# **Oakdale Planning Proposal**

## **Flood Constraints Assessment**

**Rev B**

**March 2025**

FIGURE 4-8

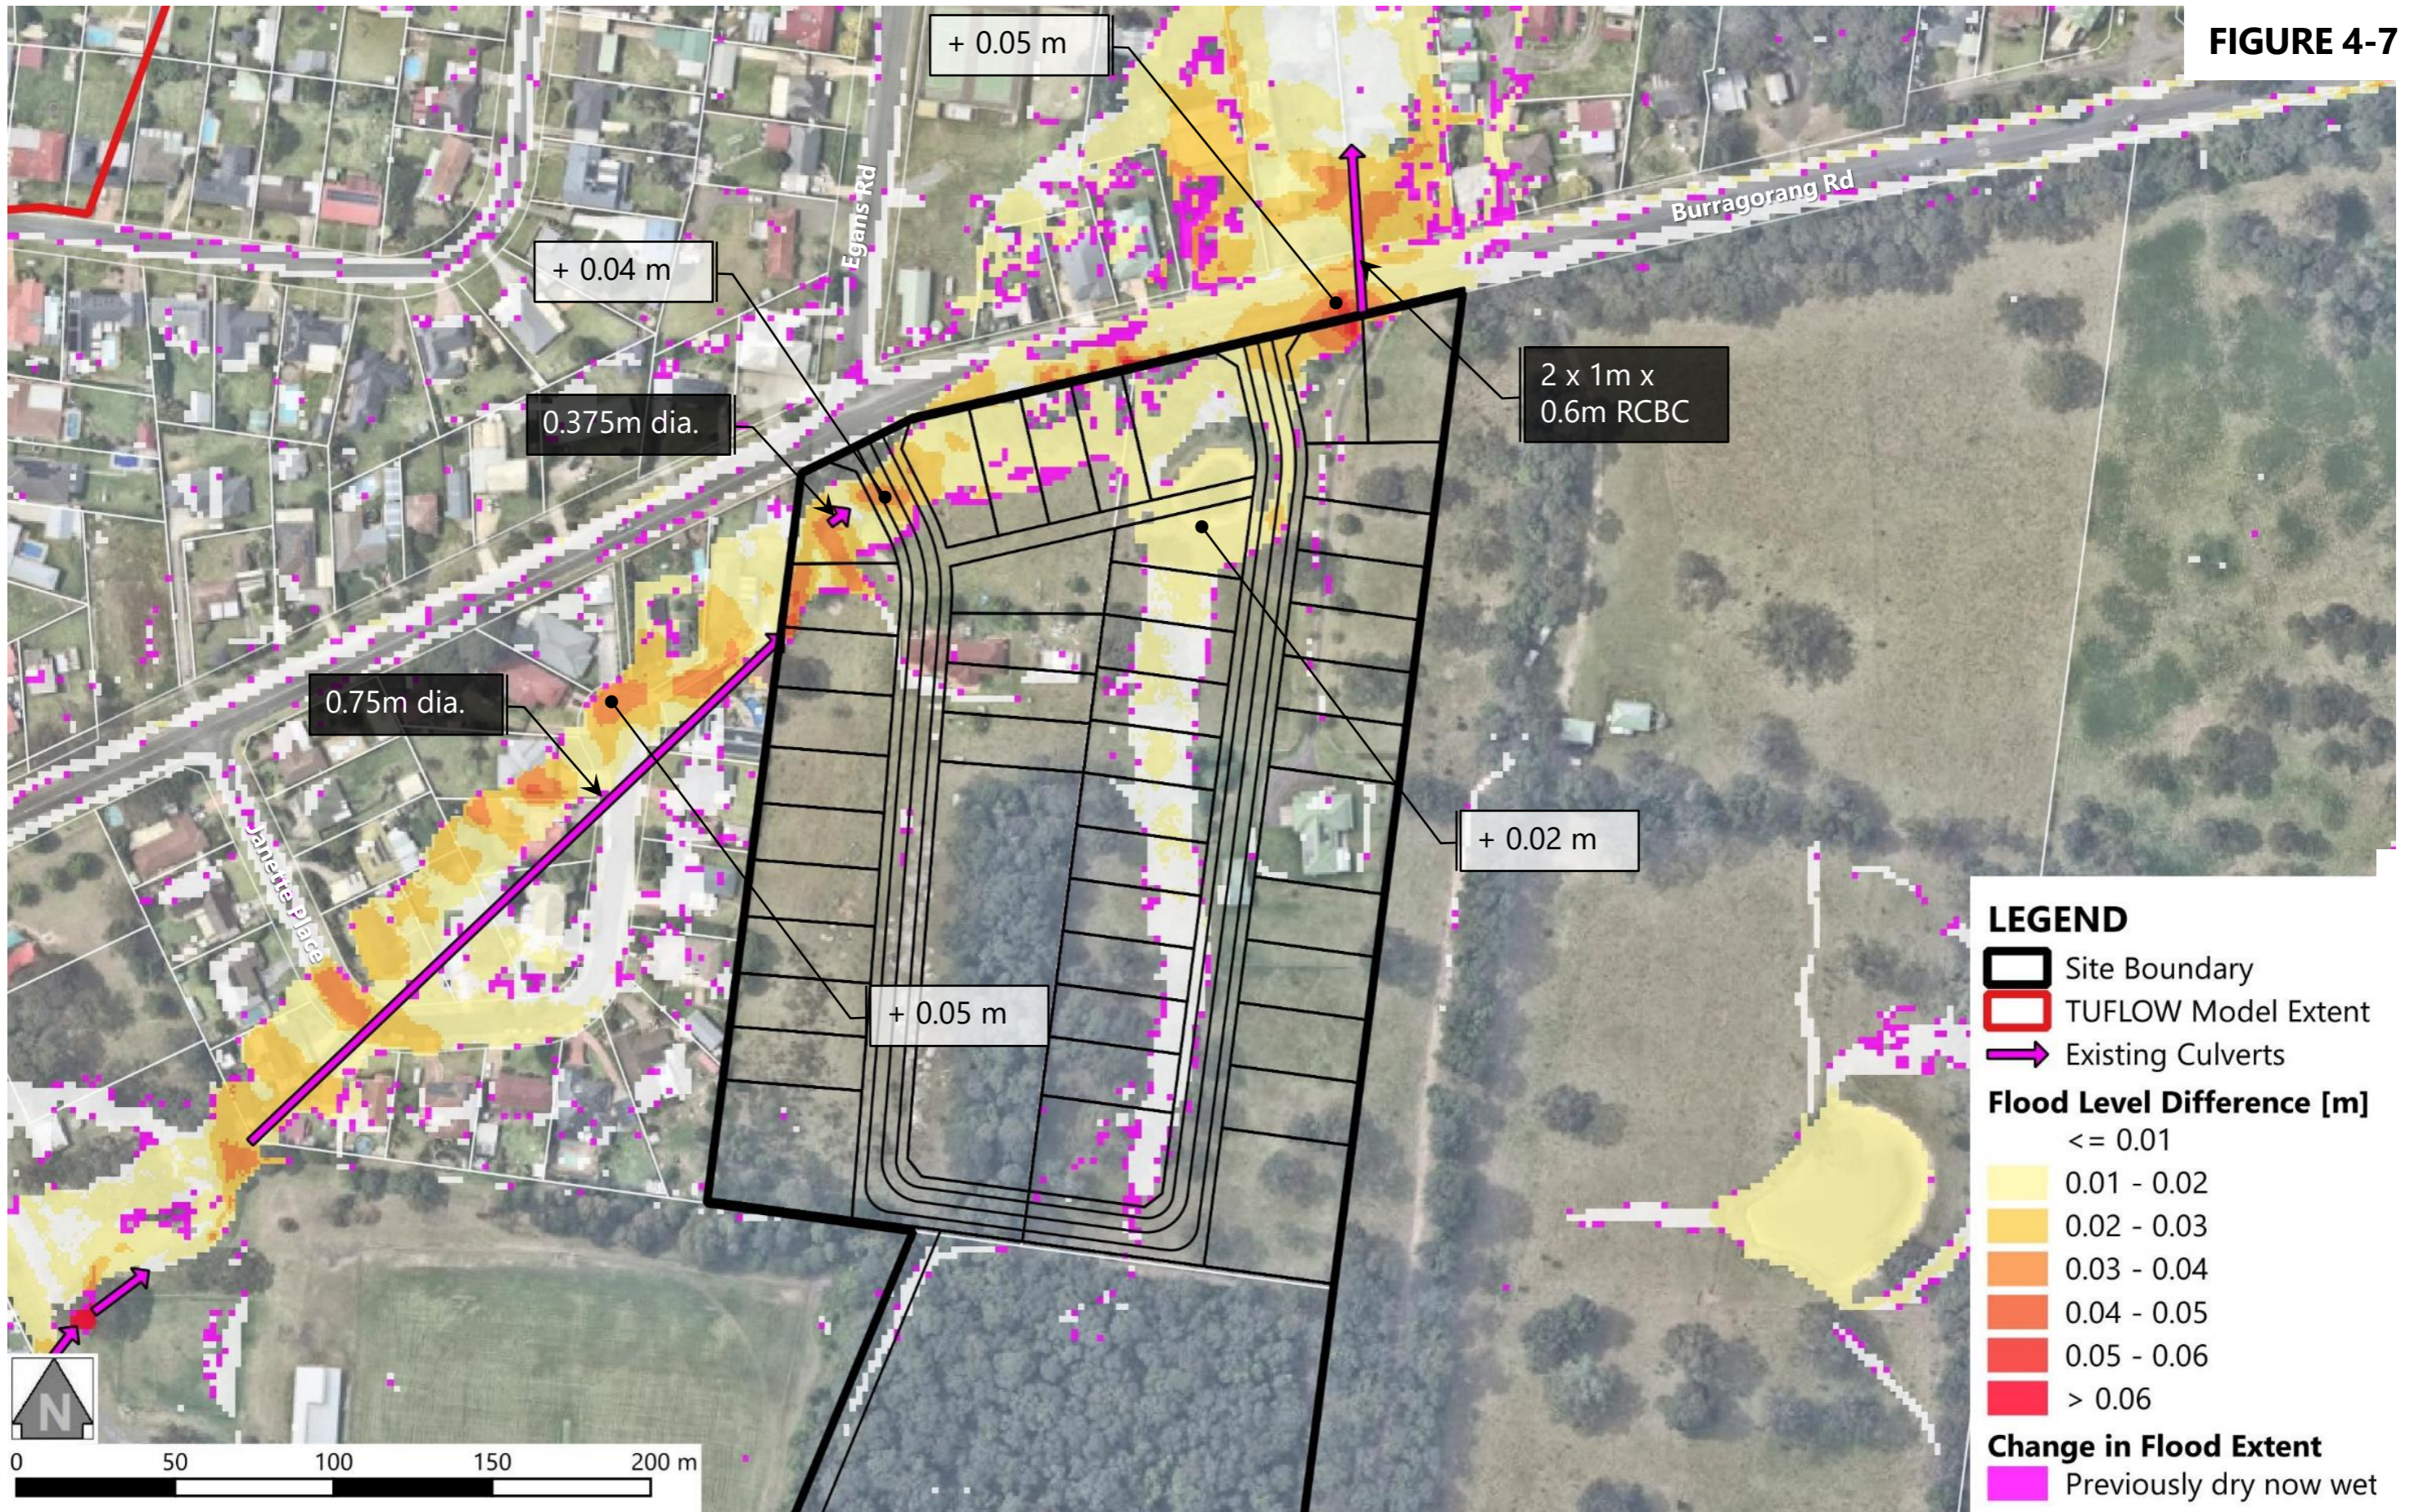
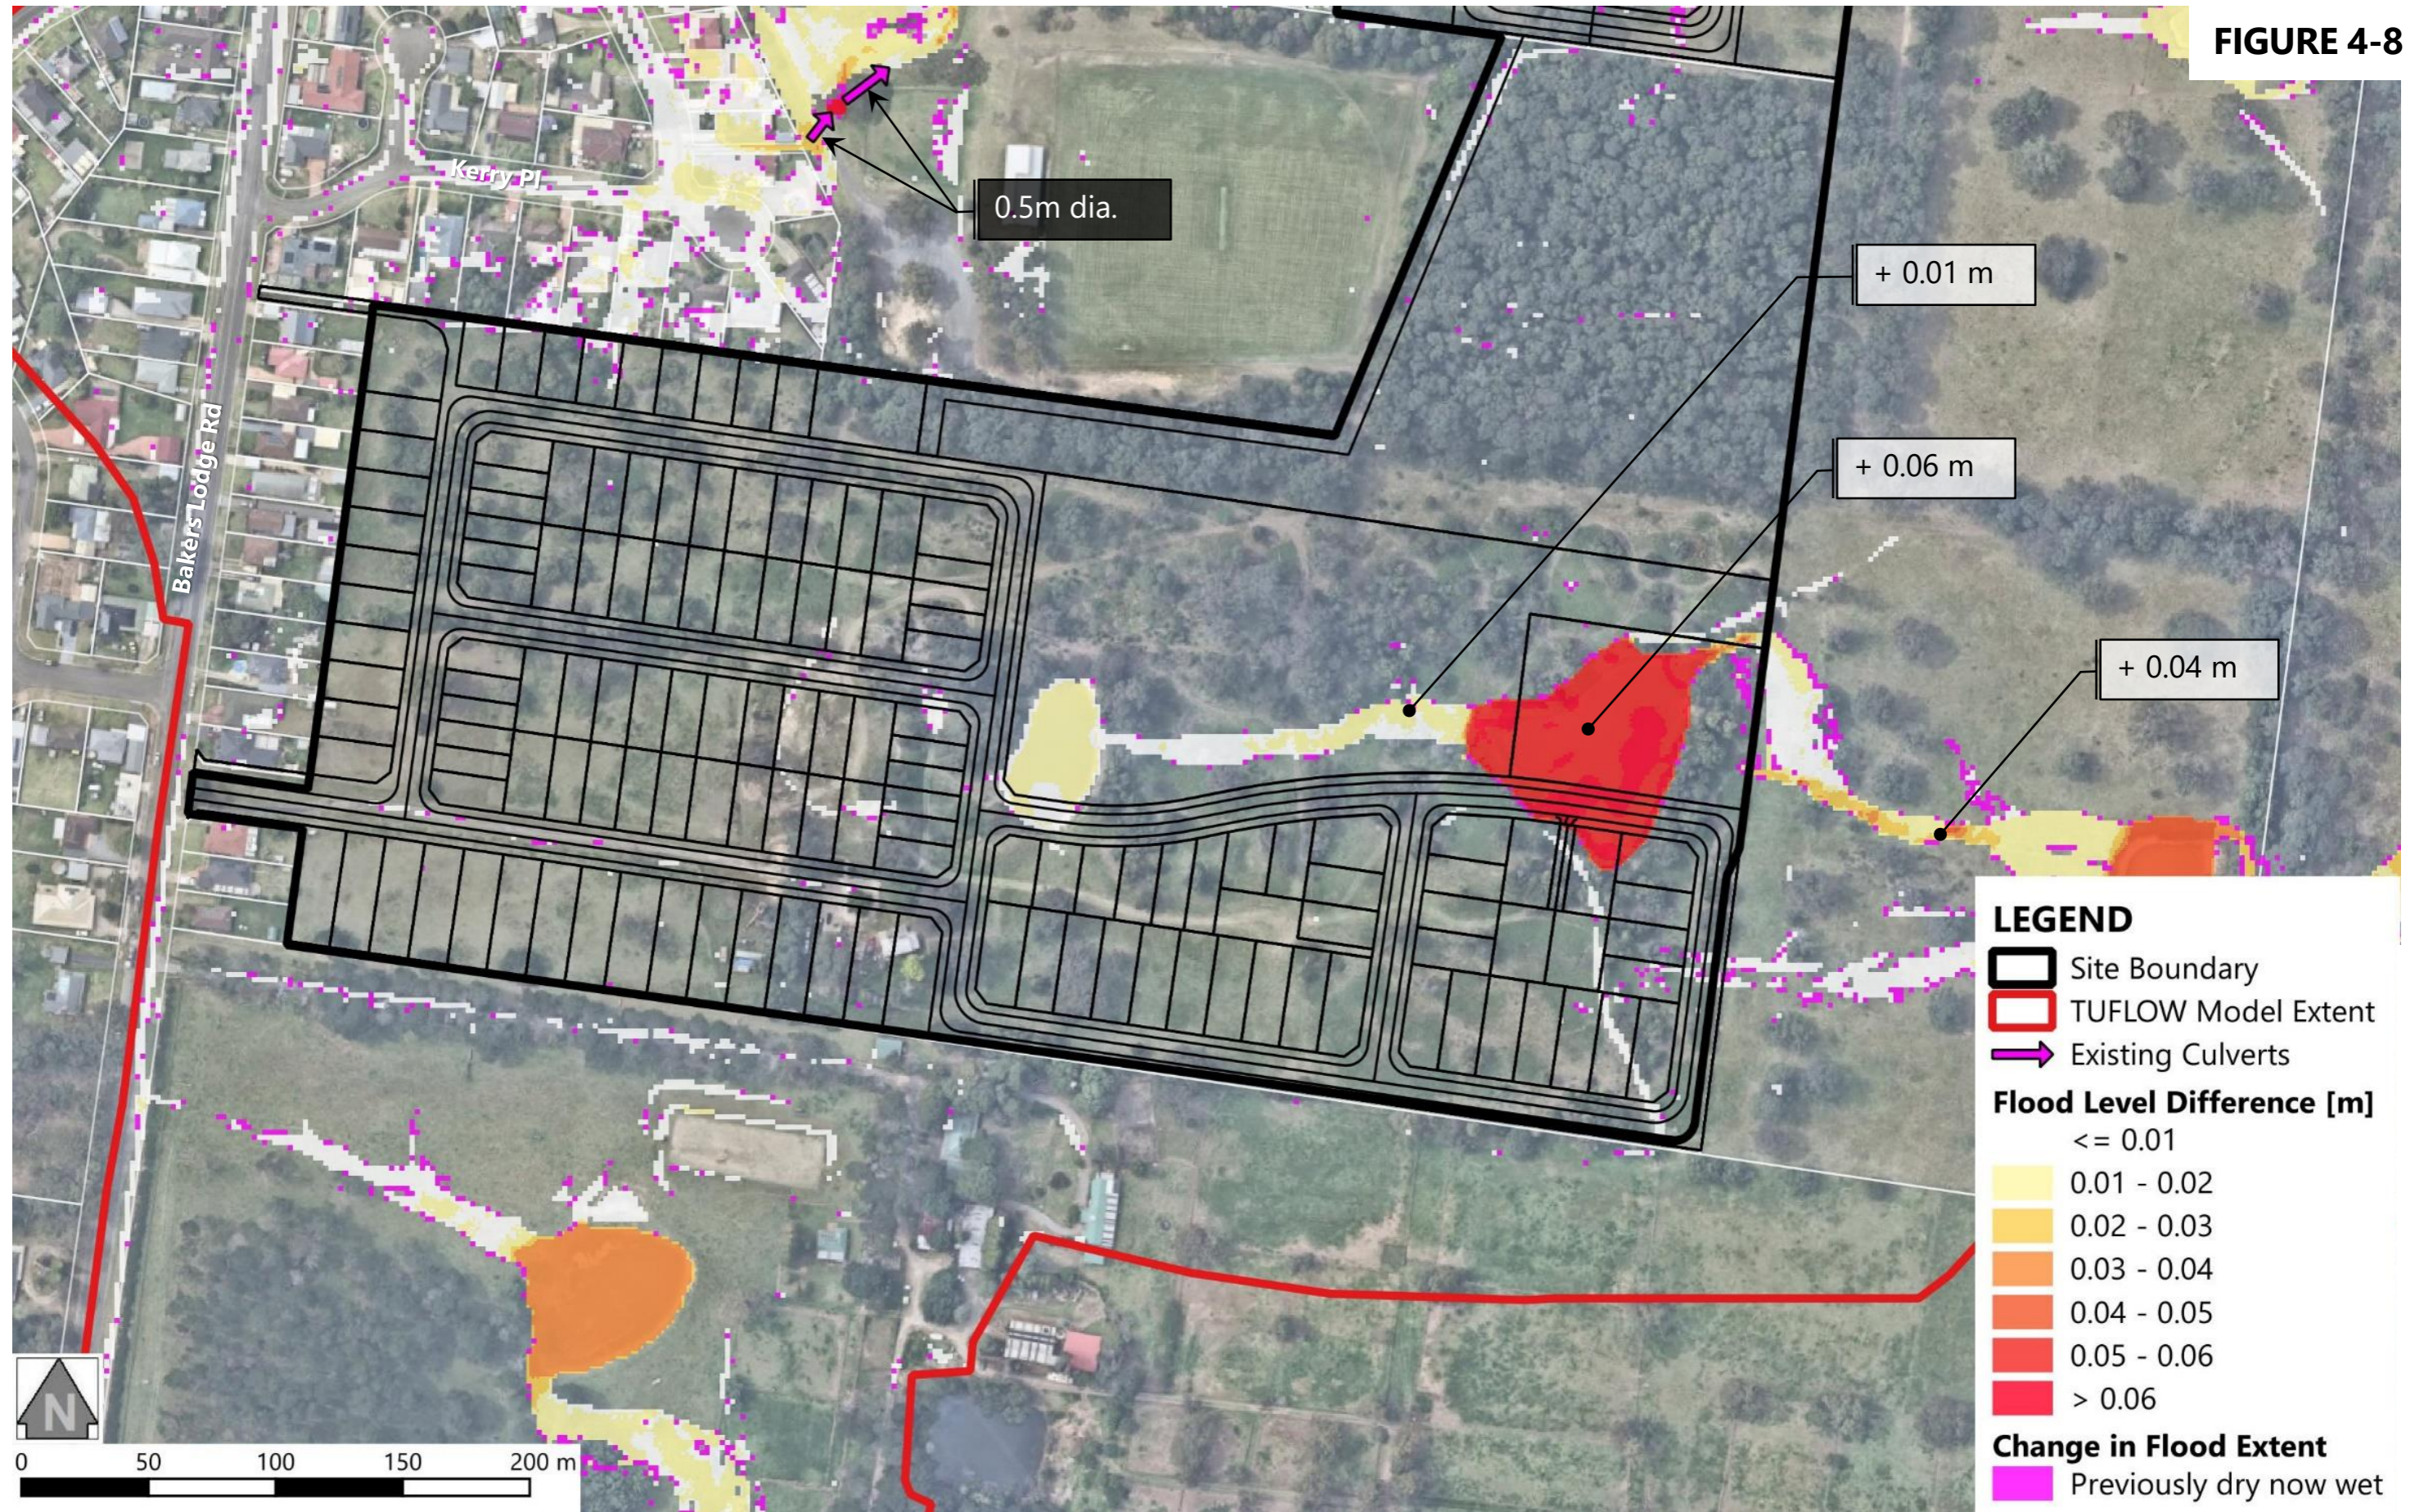
***Recommendation 5 - Address climate change impacts.***

Climate change is addressed in **Section 4.5.5** of the report and **Figure 4-7** and **4-8**.
